ALERT SERVICE BULLETIN
Bell Helicopter **TEXTRON**

NO. 212-05-122

MODEL AFFECTED: 212

SUBJECT: TAIL ROTOR BLADE P/N 212-010-750-009 THROUGH -129, INSPECTION AND REWORK OF.

Figure 1: Inspection and Rework Area

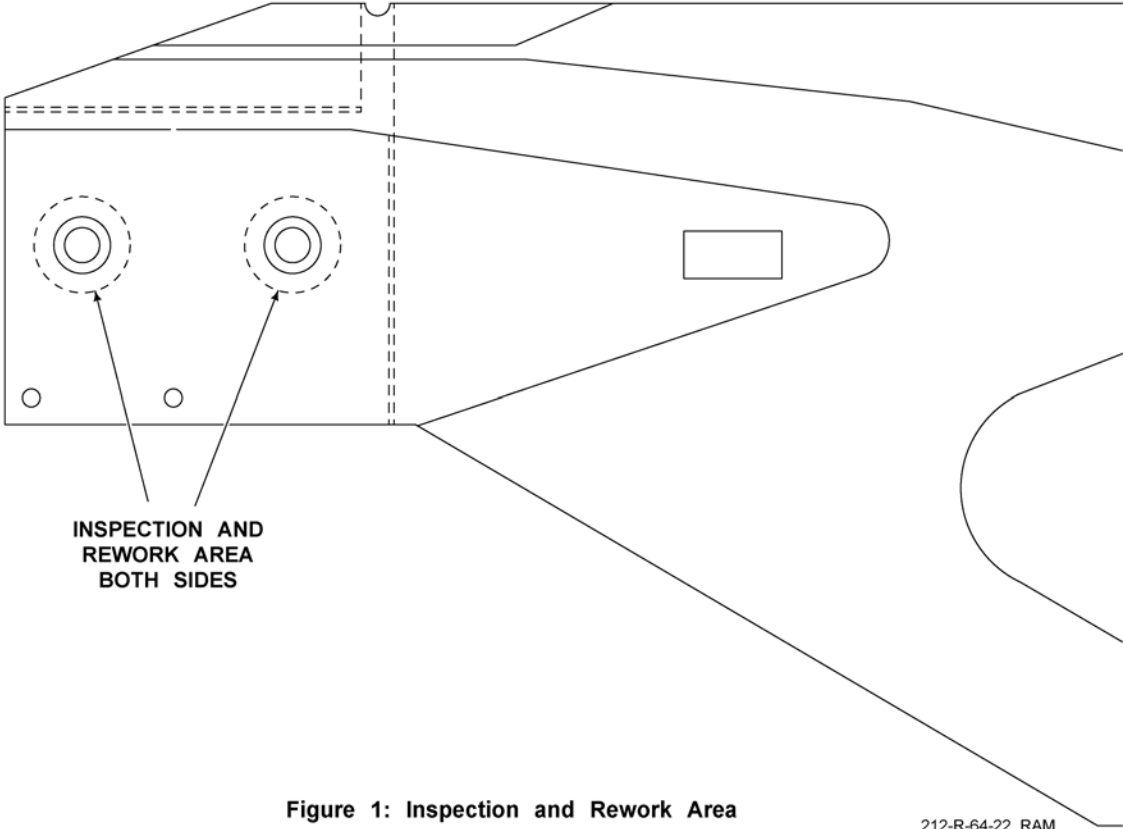
Bell Helicopter has discovered that certain serial number tail rotor blades have been manufactured with adhesive filler applied in the blade bolt washer contact area.

This bulletin is issued to identify and rework blades that have adhesive filler in the blade bolt washer contact area.

Alternate paint and adhesive removal may be accomplished by using a 180 grit cloth or paper and sanding by hand in a spanwise direction only. Surface finish of 32 RMS or better must be accomplished in the rework area after removal of adhesive using 400 grit cloth or paper. Do not remove more than .001" of aluminum material.

2. Remove paint and adhesive filler in blade bolt washer contact area per Figure 1 using plastic media blasting per the BHT-ALL-SPM.
3. Inspect reworked surface for damage and corrosion. If corrosion is found or damage beyond manual limits, send blade to Bell approved repair facility for repair.
4. Measure depth of spotface on reworked surfaces at all four locations. If depth exceeds 0.035 inches remove blade from service.
5. Apply by brush cleaner (C-344) to the bare metal surface of the reworked area.
6. Thoroughly rinse with water and dry surfaces with a clean dry rag or filtered compressed air.
7. Apply chemical film (C-100) to reworked area.
8. If buffers are damaged, replace per applicable section of CR&O.
9. Refinish blade per CR&O.
10. Install tail rotor blade on aircraft and dynamic balance.
11. Annotate records to indicate compliance with Part II of this bulletin.
